Document Update Notification

DOCUMENT NO: OP-1903.065

TITLE: EMERGENCY RESPONSE FACILITY
TECHNICAL SUPPORT CENTER (TSC)

CHANGE NO: PC-05

TECHNICAL SUPPORT CENTER
LEGEND

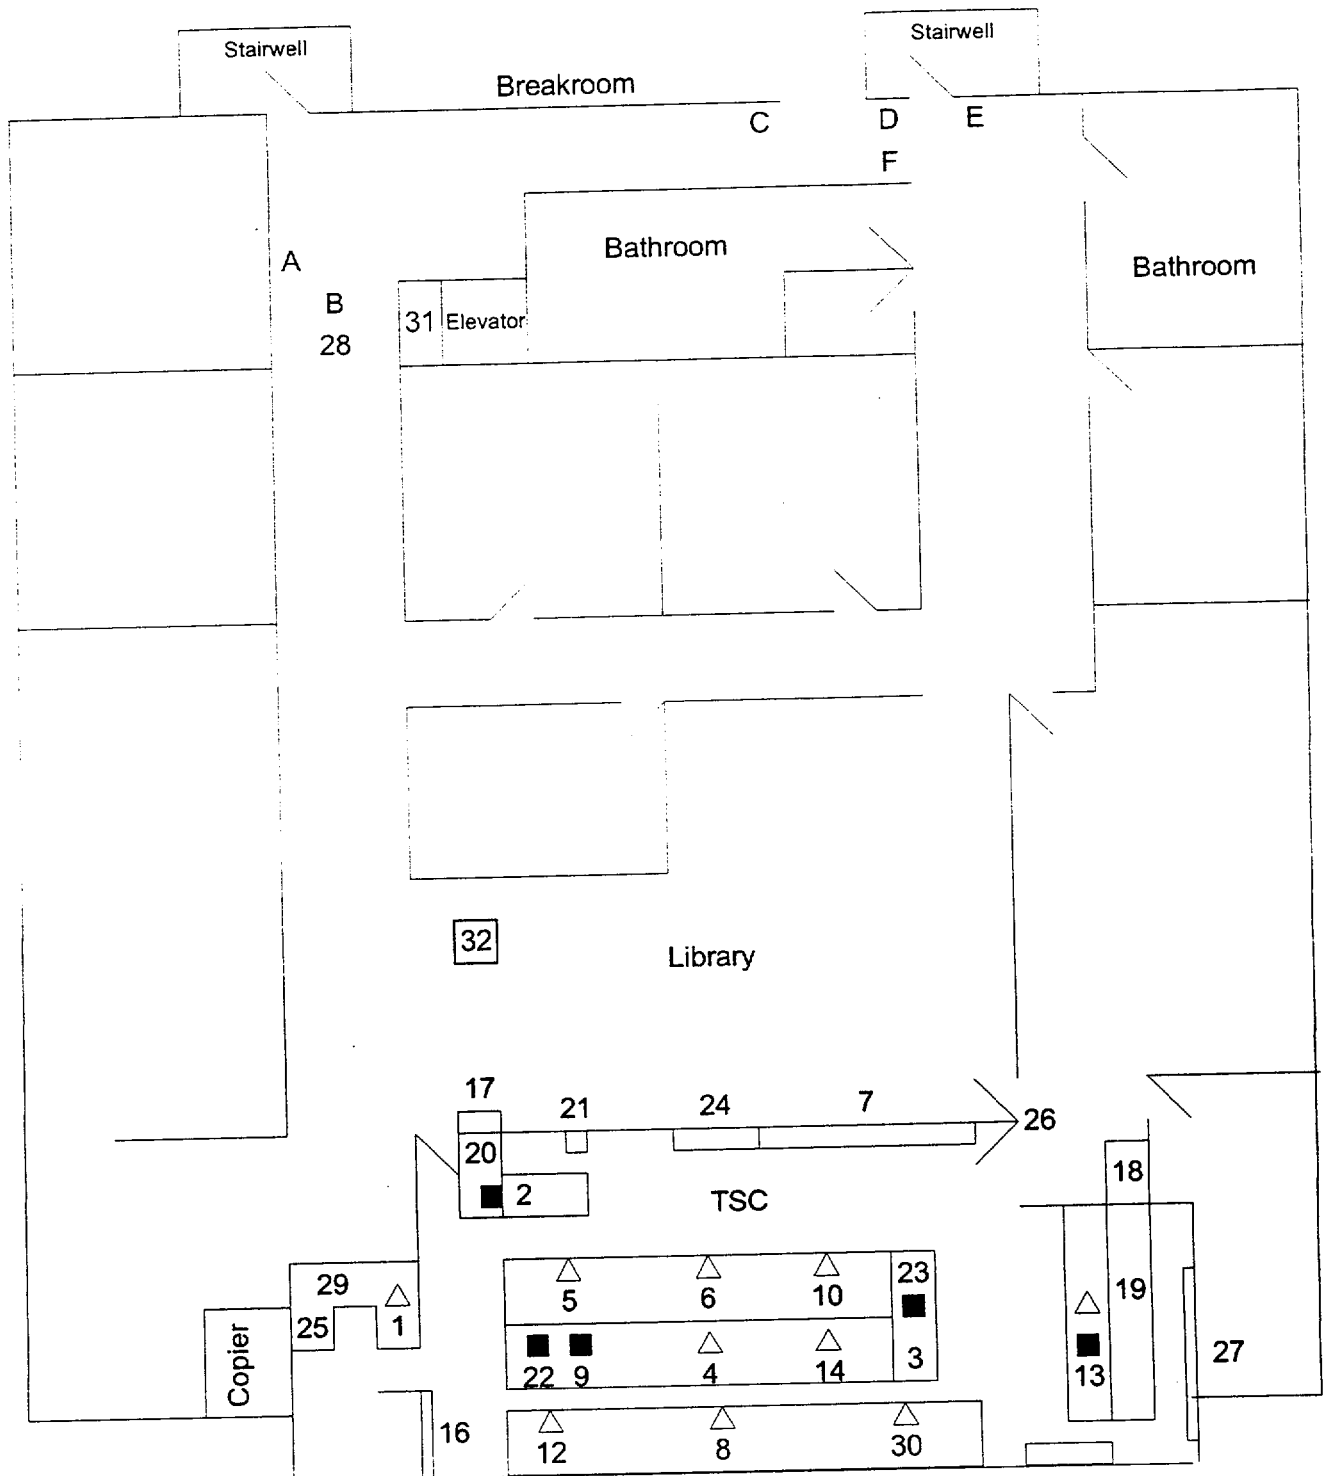
Added "3. EAL Reviewer, 7. Problems Solutions Board, 30. Operations Support" to the Technical
Support Center Legend.
Changed symbol for NRC telephone from a diamond (◆) to a square (■) throughout form.
Updated drawing of TSC.
